Errata to

MC68302 Integrated Multiprotocol Processor User's Manual

This document provides corrections to the *MC68302 Integrated Multiprotocol Processor User's Manual*, Rev. 3 and is designed to be used in conjunction with the user's manual. For convenience, the section number and page number of the errata item in the user's manual are provided. In this document, the term '302' is used as an abbreviation for 'MC68302'.

Figure 6-9. External Master Internal Asynchronous Write Cycle Timing Diagram

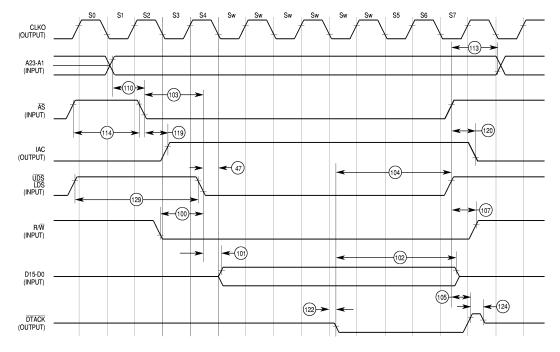
6.10, Page 6-18 Replace Figure 6-9 with the following:
